Dart Aerospace Ltd. Tuesday, 04/03/2008 1:46:31 PM Date: User: Linda Lacelle **Process Sheet Drawing Name** : BRACKET : CU-DAR001 Dart Helicopters Services Customer **Job Number** : 37677 : 10710 **Estimate Number** : D32111 **Part Number** P.O. Number : 04/03/2008 S.O. No. : **Drawing Number** : D3211 REV A1 This Issue : N/A : NC **Project Number** Prsht Rev. : MACHINED PARTS : A1 First Issue : // Type **Drawing Revision** : 33117 Material **Previous Run** : 11/03/2008 Qty: Each **Due Date** Written By Checked & Approved By New Issue 05-11-17 JLM Comment : Est Rev:A Now on Waterjet 06-10-24 JLM Est Rev:B **Additional Product** Job Number: Description: Seq. #: Machine Or Operation: M2024T3S063 2024-T3 .063 sheet 1.0 Comment: Qty: 1.4753 sf(s)/Unit Total: 8.8515 sf(s) Material: 2024-T3 (QQ-A-250/4) 0.063" thick (M2024T3S.063)Identify as D3211-1 2.0 Comment: FLOW WATER JET 1-Cut as per Dwg D3211 Dwg Rev: A1 Prog Rev: A 2-Deburr if necessary 3.0 QC2 Comment: INSPECT PARTS AS THEY COME OFF MACHINE 4.0 QC8 SECOND CHECK Comment: SECOND CHECK SMALL & MEDIUM FAB RESOURCE 1 5.0 SMALL FAB 1 Comment: SMALL & MEDIUM FAB RESOURCE 1 Deburr Form: rprocess Page 1

PAR #: NIA Fault Category: Prod F

| | | | | * | | | · |
|--------|-------|-------|------------|-------------|------------------------|--------------------------|--------|
| | | | 4 | D3211 | * | SHEET | 1 OF 2 |

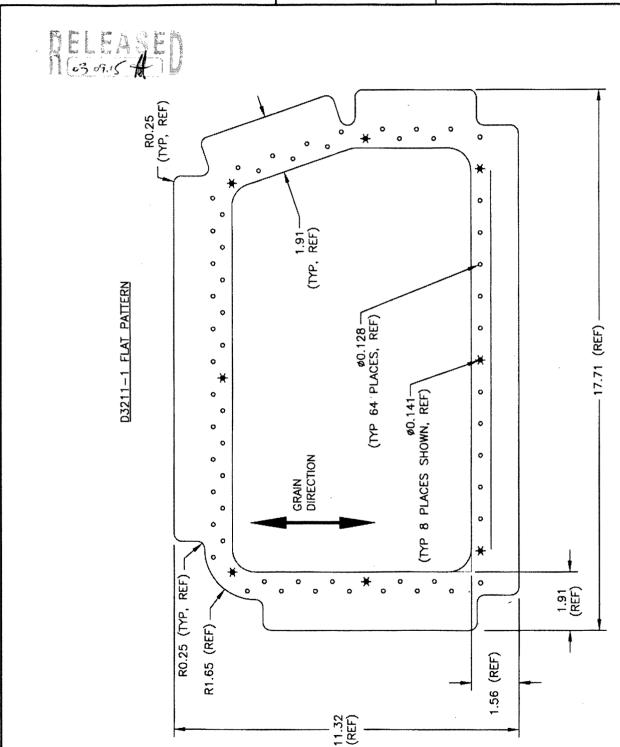
| °W/O: | | WORK ORDER CHANGES | | | | | |
|-----------|--|---|----|------|-----|-------------------------------|--------------------------|
| | | Grain direction needs to be changed to 45 degrees due to bending on all | | | | B 03712 | B 08.03.05 |
| | | H sides | | | | | ` |

| NCR: 37677 WORK ORDER NON-CONFORMANCE (NCR) | | | | | | | | |
|---|------|------------------------------|-----------------------------|------------------------------|----------------|--------------|-----------|-------------|
| 28/03/05 | Ç | 3 piece broke at the bend | B | Suapa distras No replace | 08/03/05 | 0803.05 | Bogen | 08034 |
